From: [Winslow, Frank \(ECY\)](#)
To: ["Lisa Thompson"](#)
Cc: [Suzy Stumpf](#)
Subject: RE: XN0032 - Block 10 Site - Remedial System Operations and Cleanup Objectives
Date: Friday, August 16, 2024 8:44:29 AM
Attachments: [image001.png](#)
[image002.png](#)
[image003.png](#)

Subject: Block 10 Site (VCP Project ID: XN0032) - Cleanup Action Report

DPE 34: Groundwater Elevation vs PCE Concentration

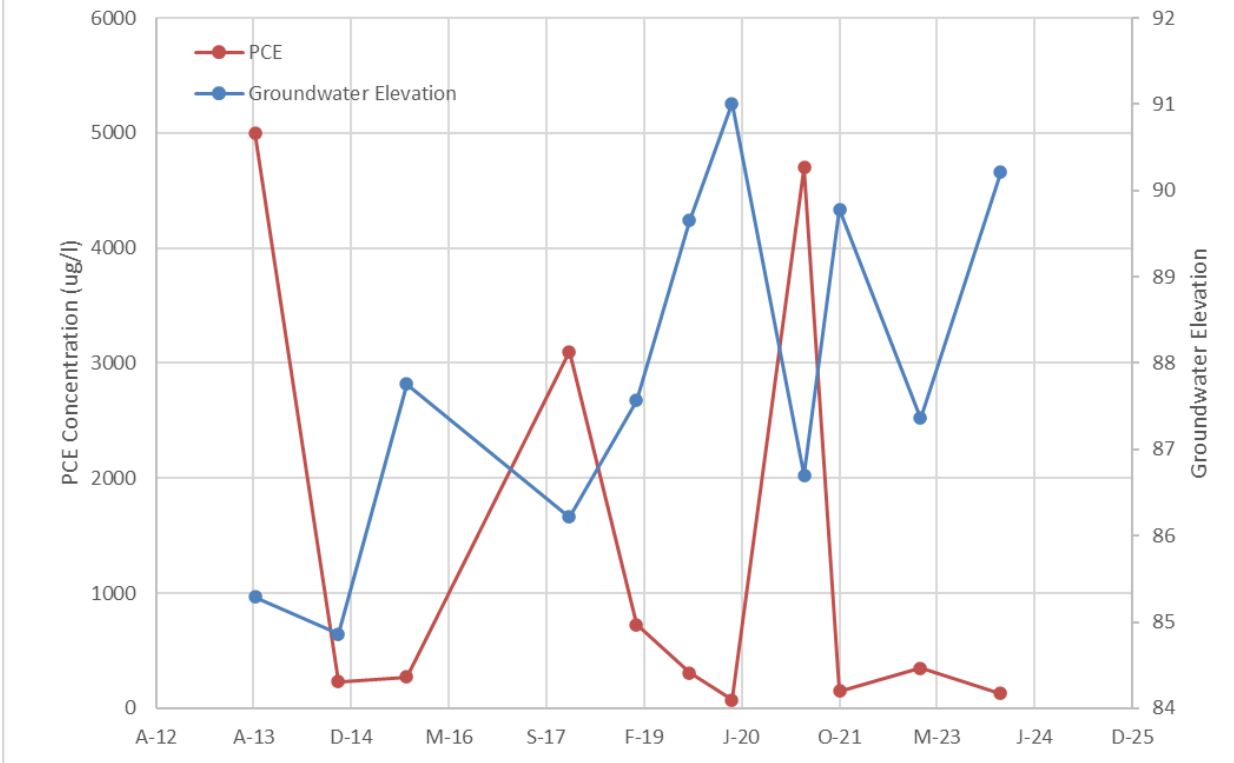
- *The apparent rebound in the system influent following system shut off in 2023 (CAR Table 12);*
- *The highly variable PCE results in DPE-34 over time (spiking up to 4,700 µg/L in May 2021); and*
- *The increase in TCE concentrations in DPE-35 from January 2018 to September 2019.*

With respect to the relationship between spiking concentrations and pumping at DPE-34 and DPE-35, my understanding is that Farallon does not believe that any correlation between pump cycling and the elevated concentrations (spikes) observed at DPE-34 and DPE-35 can be drawn. However, I have not seen any charts or data showing pump runtimes from DPE-34 and DE-35. Supporting that conclusion with a data presentation may be appropriate. If the observed spikes are not attributable to specific pumping scenarios, does Farallon have an alternative conceptual model?

For the groundwater sampling events prior to May 2023, the downwell pumps were turned off approximately two weeks prior to the event. Prior to turning off the pumps, they were on and cycling when water was present above the pump inlet. There are no flow meters on the individual lines, so it is not possible to record the flow from each individual pump. However, it does appear that the concentrations of PCE and TCE at DPE-34 and DPE-35 increase during times of lower groundwater elevations, see draft charts below.
